AFFORDABLE HOUSING
DEVELOPMENT SSD-83256463
ARCHITECTURAL DRAWINGS
THE BOULEVARDE
PUNCHBOWL
COLLINS AND TURNER
SEPTEMBER 2025

No	Date	By	Note
B	9/12/2025	DC	For RTS

Project	
Affordable Housing Development SSD-83256463 150 The Boulevard and 34 Dudley Street Punchbowl, NSW

Drawing Title Sun Eye Diagrams

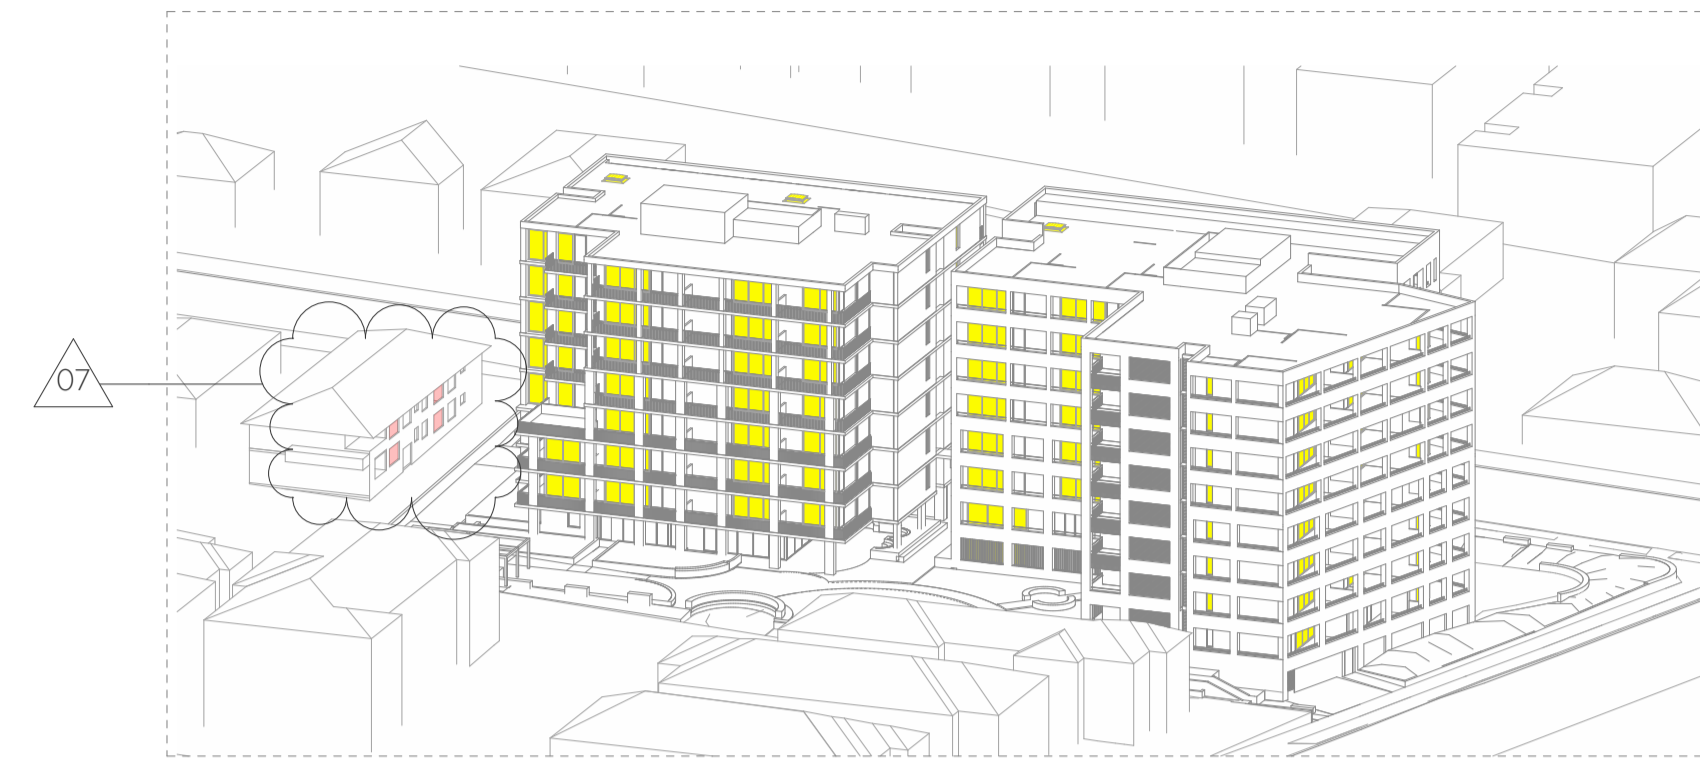
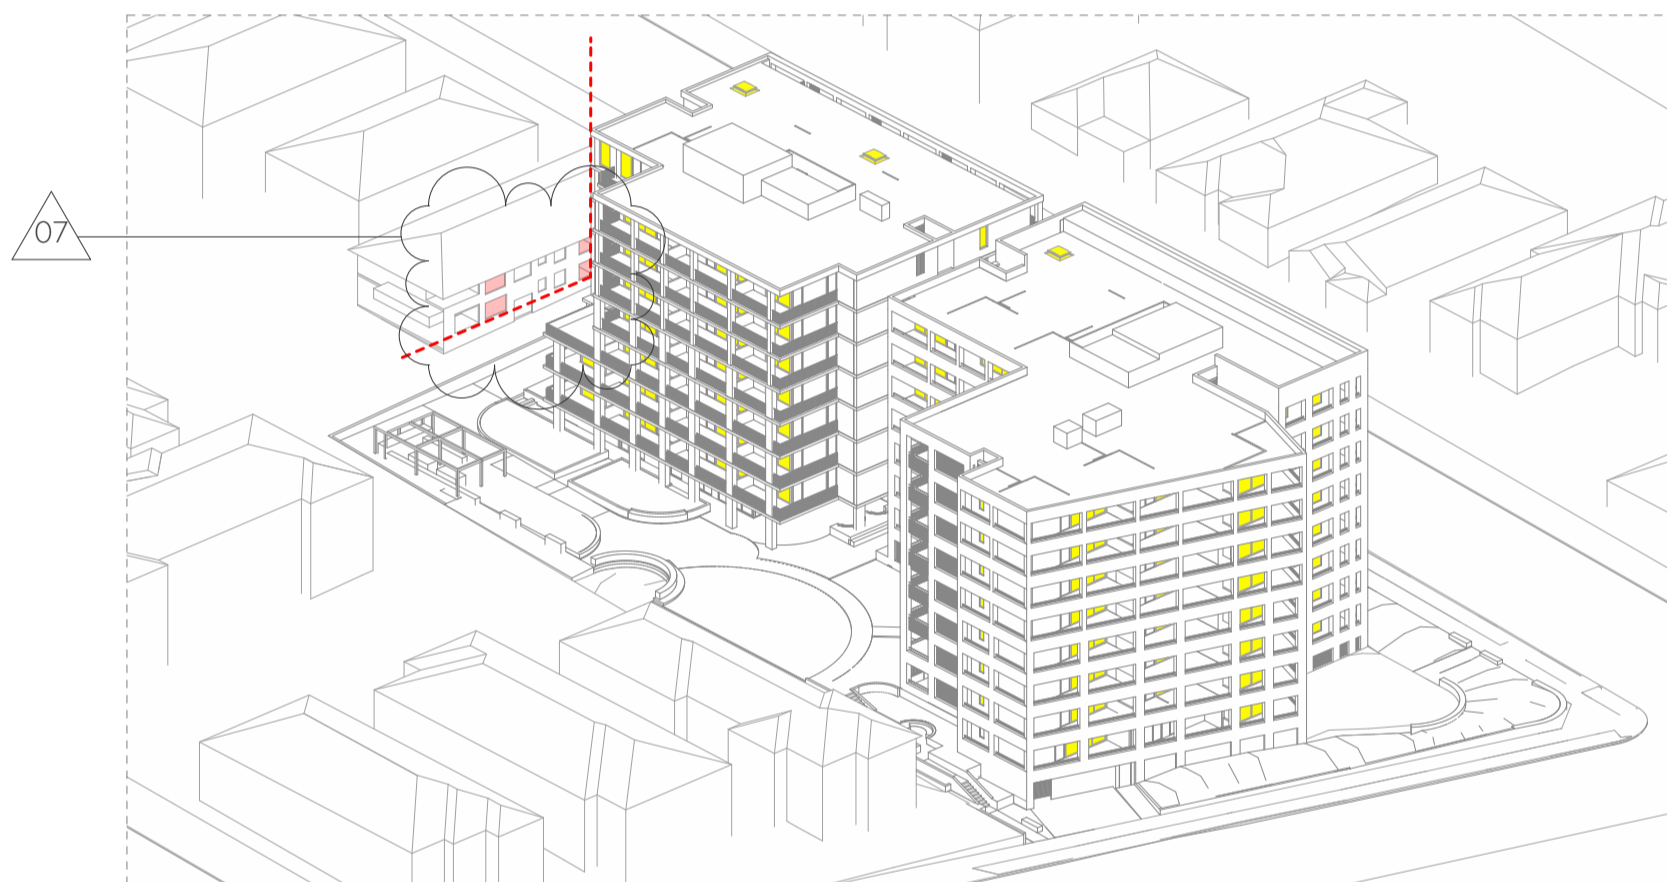
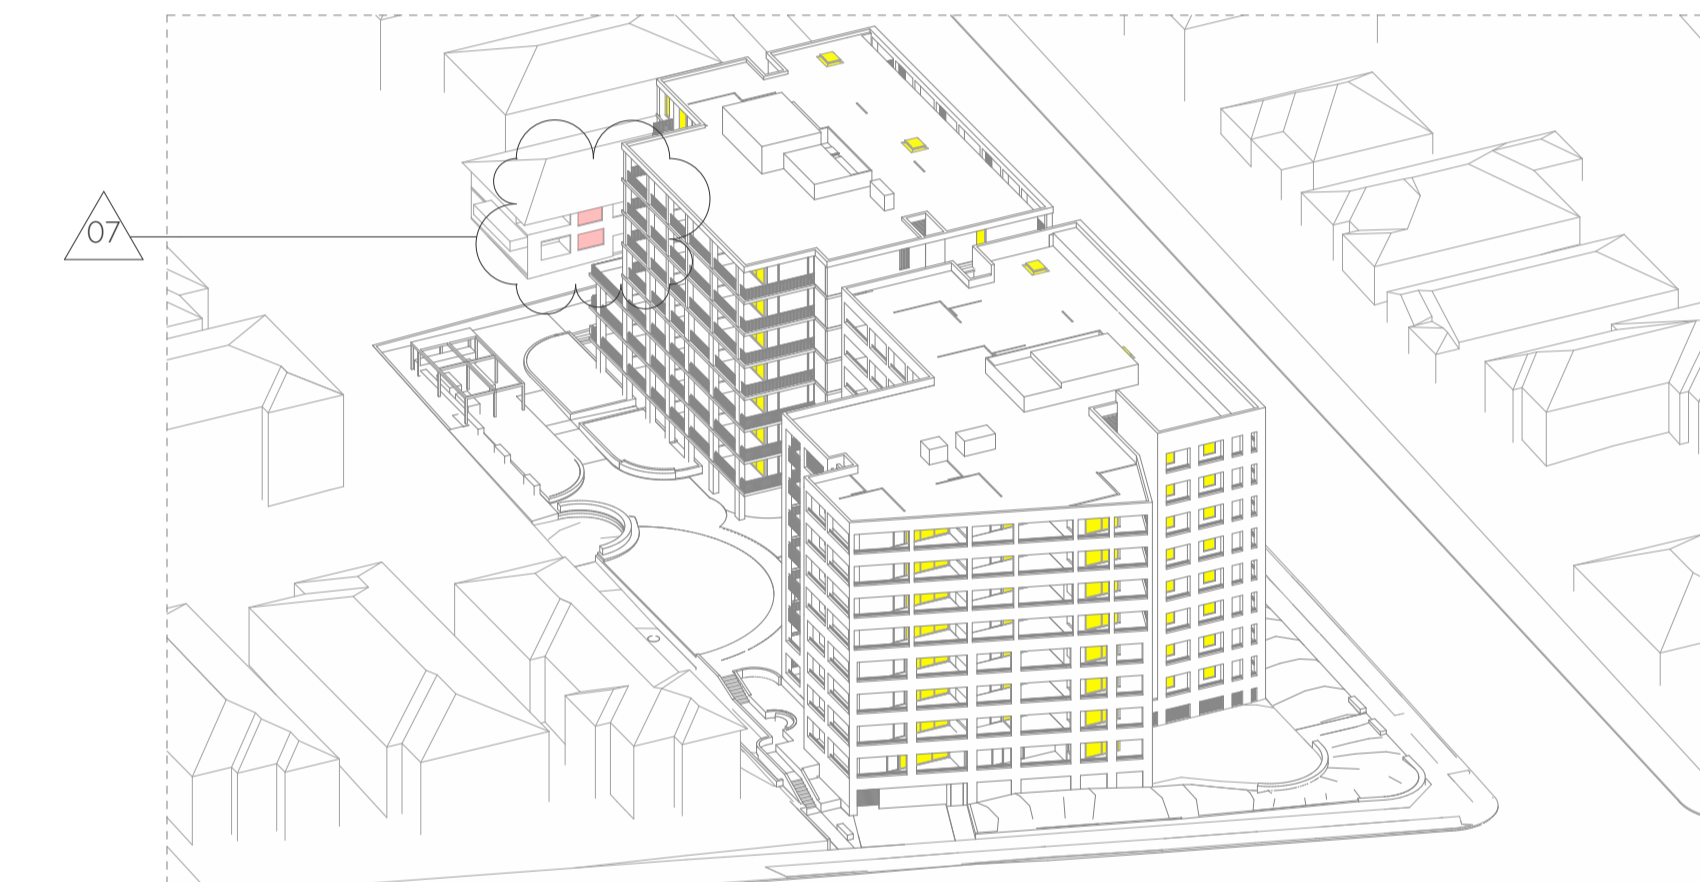
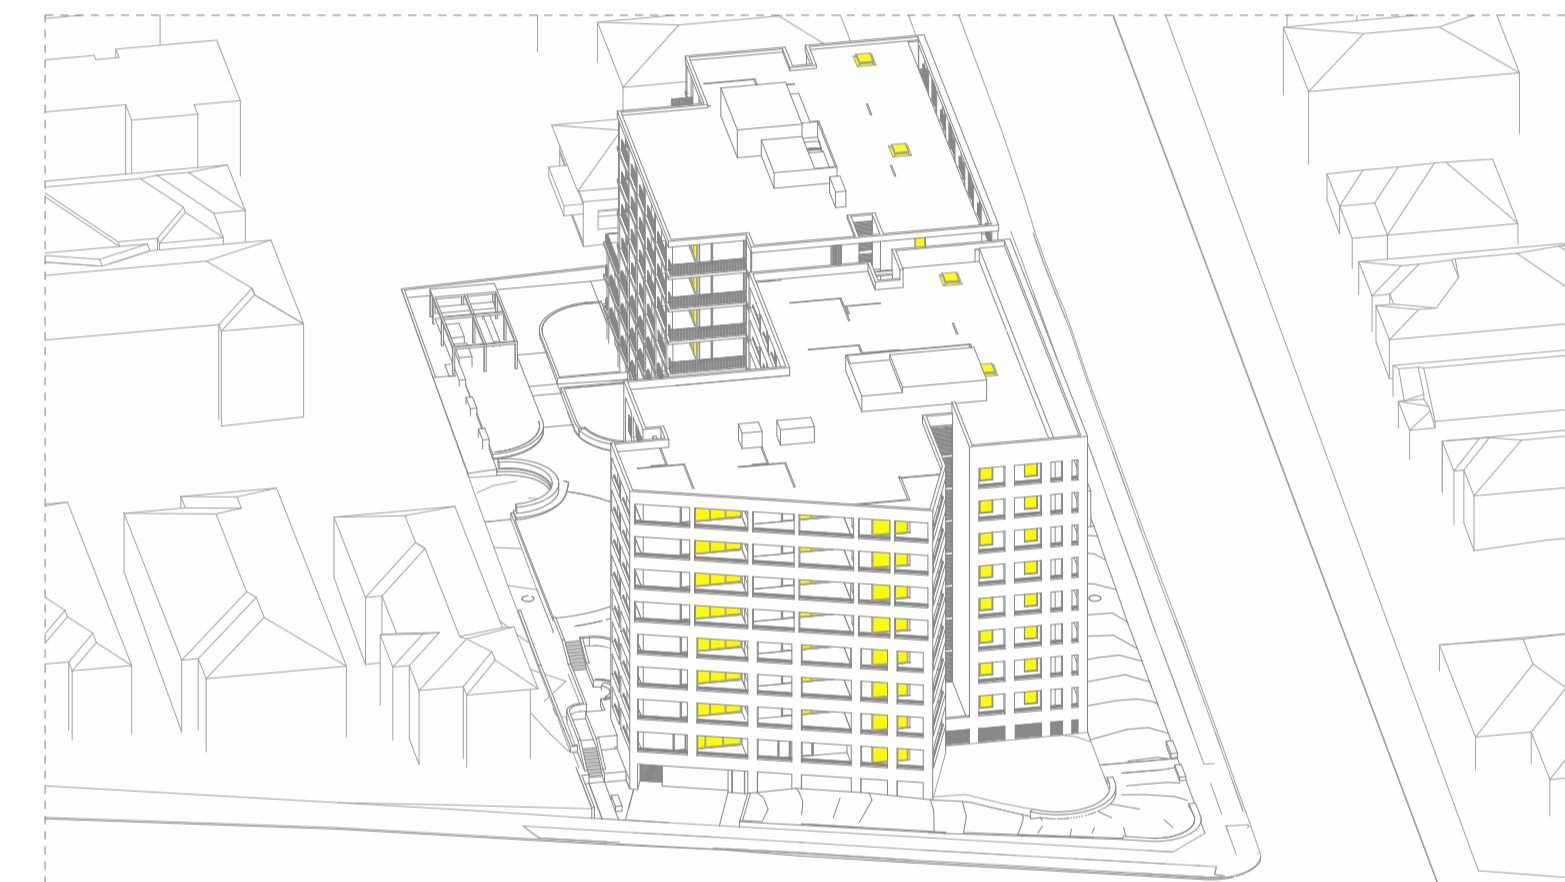
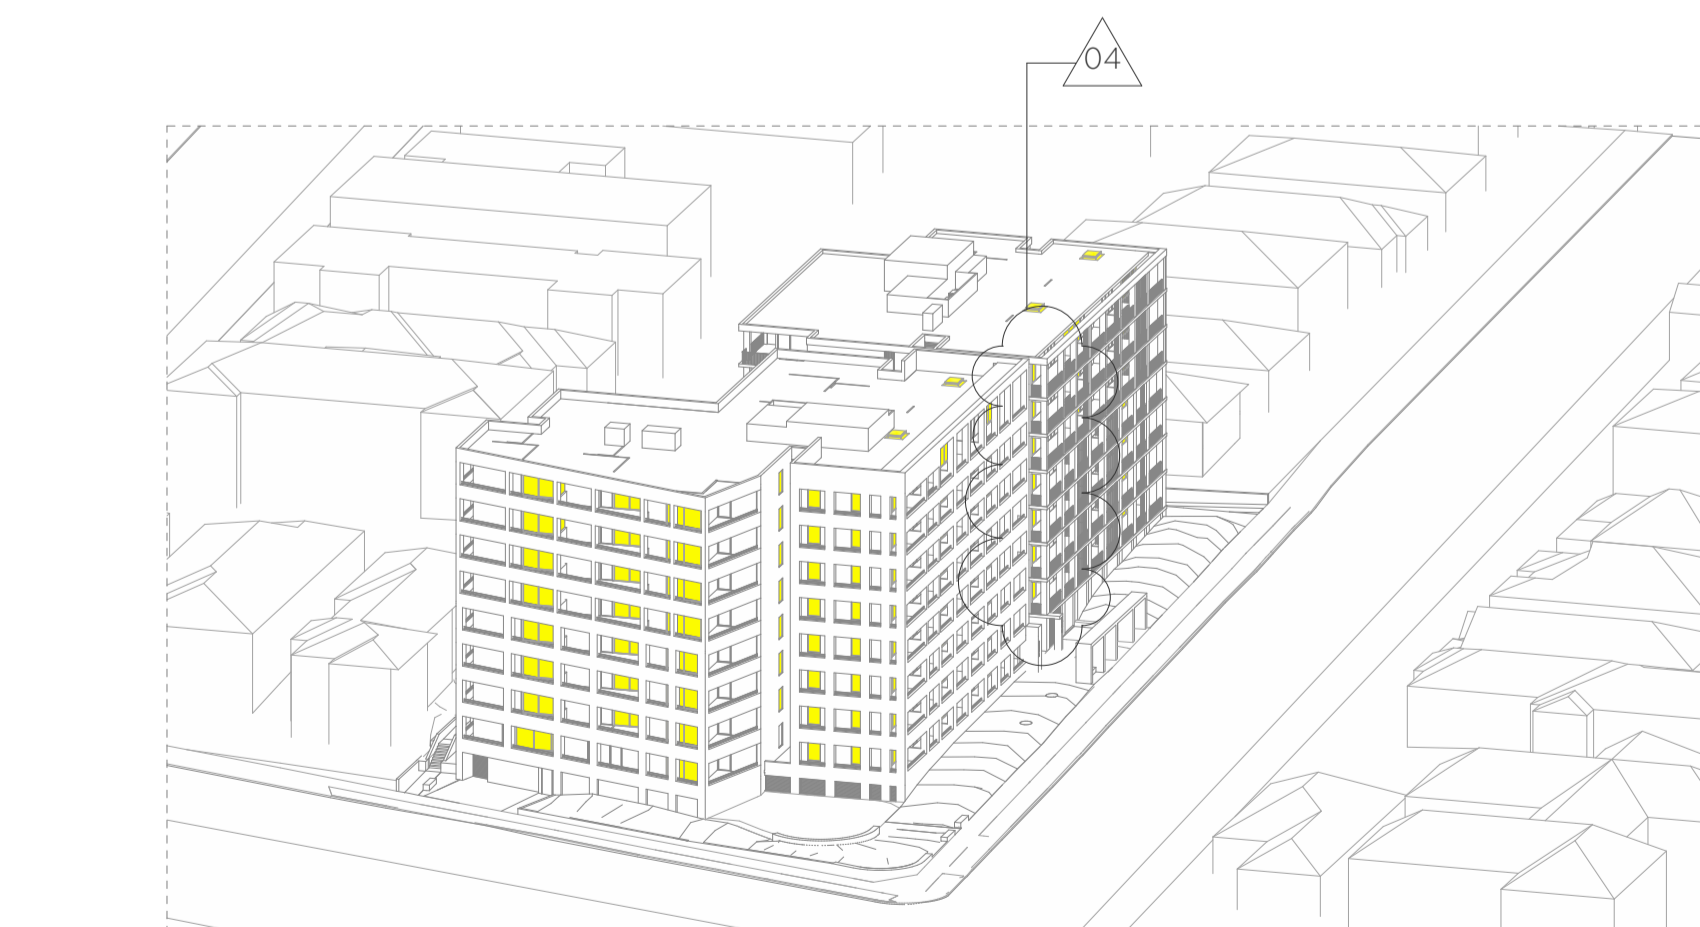
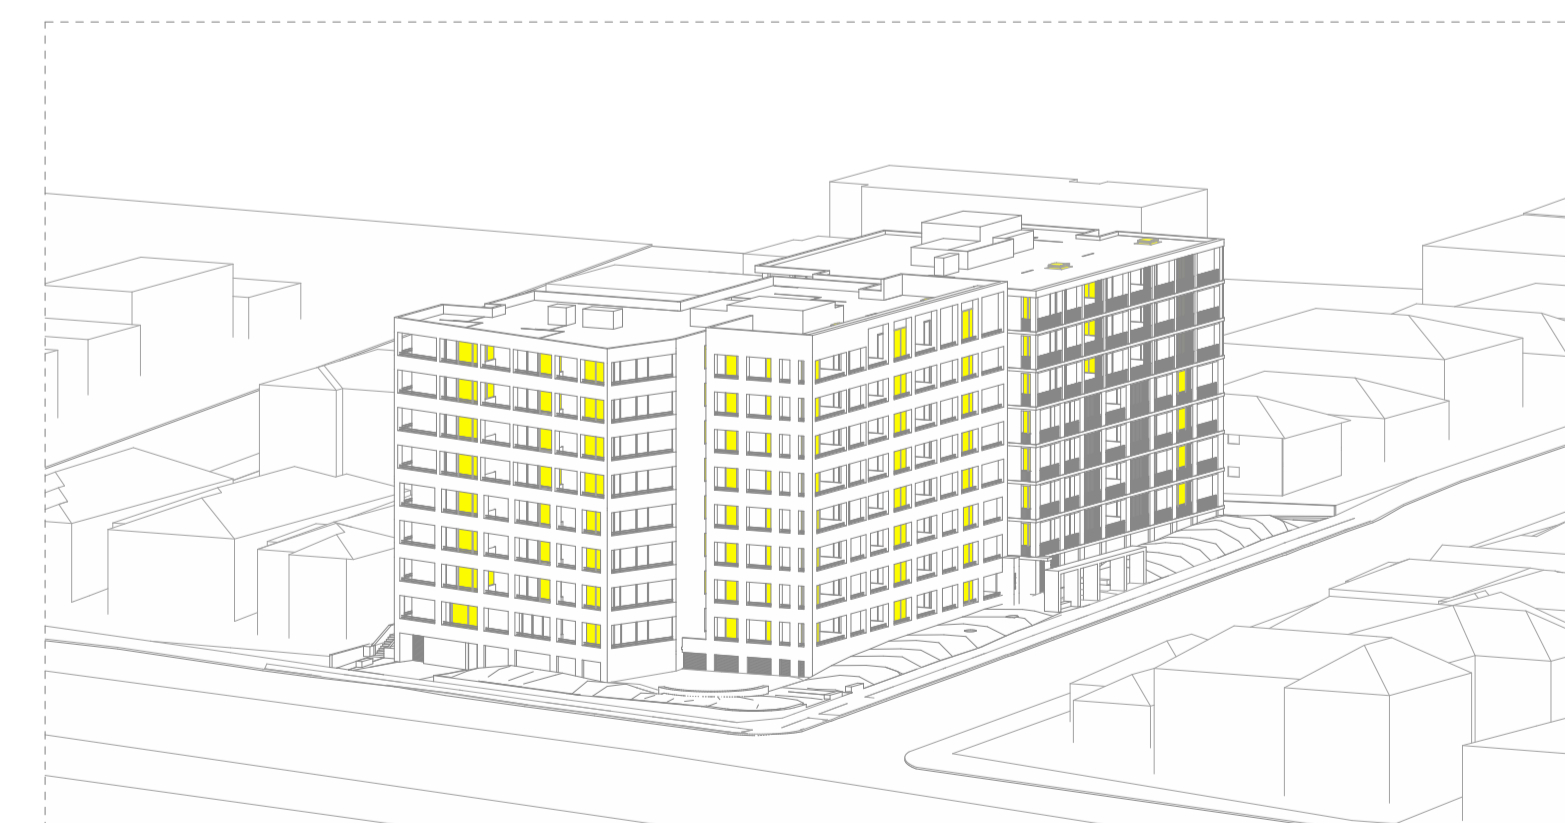
ID	Name
04	Facade opening added Refer to RTS Item DPHI 6
07	All No.36 living room windows identified Refer to RTS Item DPHI 9 and CB-TP 1.4
